RE: Septage Facility – Field Inspection Report #21-30 and **Facility Requirements**  
Hopkinton Septage Lagoons, 491 East Pembroke Road Hopkinton, NH  
NHDES Permit #: **SEF-00-001**; Groundwater Permit #: **GWP-198705021-H-006**.

## FACILITY INSPECTION REPORT

### Inspection Report #: 21-30

RE: Septage Facility Permit Modification (Renewal) Application – Comments  
Hopkinton Septage Lagoons, 491 East Pembroke Road Hopkinton, NH  
NHDES Permit #: **SEF-00-001**; Groundwater Permit #: **GWP-198705021-H-006**.

Photo #5 – Lagoon 1 Example of Eroded Interior Berm  
(Looking North)

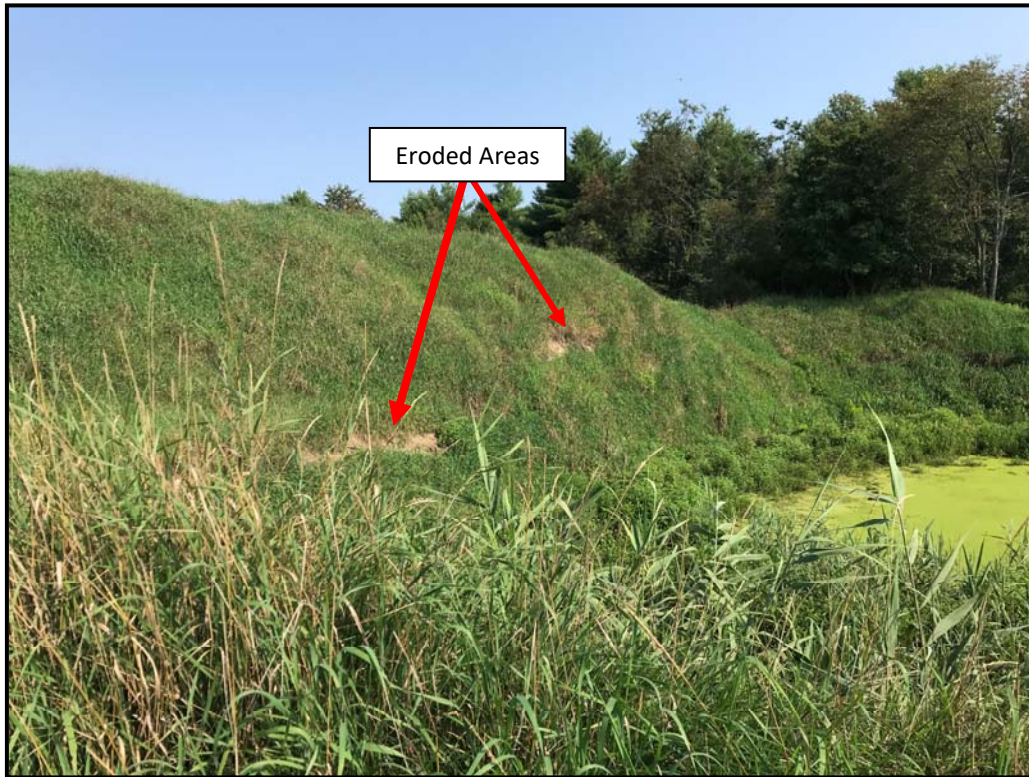
- Lagoon 1 is located in the northwest corner of the fenced facility, on the north side of the entrance. (See **Photo #2**, attached.) It is currently active with a hauler quick-disconnect coupling and hose noted in-place within a PVC culvert through the southerly lagoon berm (**Photo #3**). A puddle of water was noted in the gravel access road in front of the hauler discharge location (**Photo #4**). All berms are steep, heavily vegetated with very tall grass/weeds, with irregular crests – more like stockpiles side-by-side. The south berm is approximately 8 feet tall above the gravel access drive elevation; the other berms are approximately 25 to 40 feet high above the gravel access drive elevation.

The interior lagoon contained a pool of liquid septage with a green algae surface. The water surface of this pool is approximately 20 feet below the access drive elevation. All interior berms and around the contained septage pool, are heavily vegetated. Some areas of the interior berm/slopes appeared to have sloughed off, exposing bare material. (Refer to attached **Photo #5.**) A 40-gallon plastic trash barrel was noted adjacent to the hauler discharge hose location, for disposal of any trash by the hauler.

Some plastic debris was noted on the outside of the easterly berm. RMS also noted a couple of plastic pieces of debris on the gravel access drive between Lagoon 1 and 5. Ms. Houston asked Ms. Cochrane if there is any screening or removal of non-biodegradable debris performed by the haulers, as they discharge to an active lagoon – her response was "no – if there was anything like that... it would need to be moveable, between the lagoons..." Ms. Houston advised her that there are pre-made, movable bar racks available, and that the Town of Pittsburg had constructed their own, that is moved around their facility. The problem with allowing the debris to remain in the septage, Ms. Houston relayed, is that the options for septage solids disposal are limited to either disposal at a permitted landfill, or if debris can be screened out of the solids, it may be used as beneficial topsoil additive on or off the property if it meets quality/standards for land application.

Photo #11 – Lagoon 5 (Looking Southeasterly)

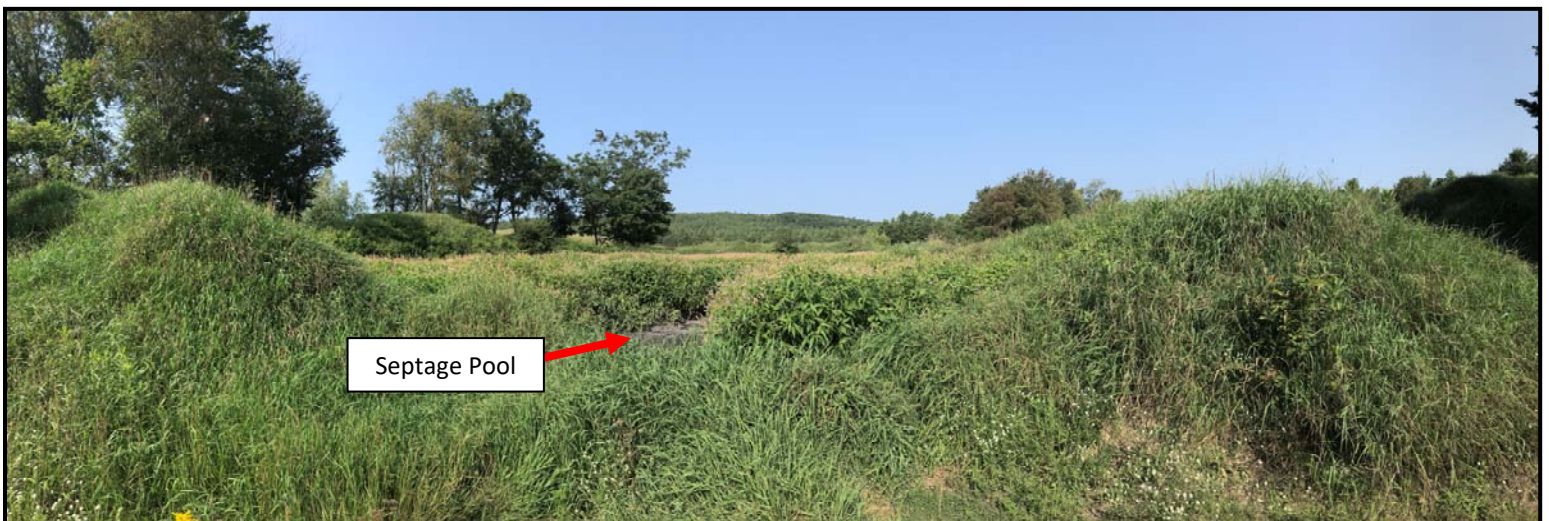
8. Lagoon 5 is also out of compliance with Env-Wq 1609.09(e)(2), which requires that all lagoons shall be “(M)aintained to provide a minimum of 2 feet of freeboard at all times...”.

- Lagoon 5 is located at the southwest corner of the SEF, near the south side of the entrance, and is active. Ms. Cochrane relayed that she thinks only one hauler discharges to this location. This lagoon did not appear to have a complete east berm, to allow placement of the hauler's hose on the ground in the northeast corner of the lagoon, for gravity discharge into the lagoon. (Refer to **Photo #11**.) There was no piping/hose or operational equipment noted near this lagoon. The berms for this lagoon are lower in height than the other lagoons, ranging from approximately 8 to 15 feet above the access drive elevation. All berms and the lagoon bottom are heavily vegetated with tall grass/weeds. A small pool of liquid septage was noted in the bottom of the lagoon with a "scum layer" evident on the surface. The pool surface appeared about 3 feet below the access drive elevation. No piping/hose or operational equipment was noted near this lagoon.
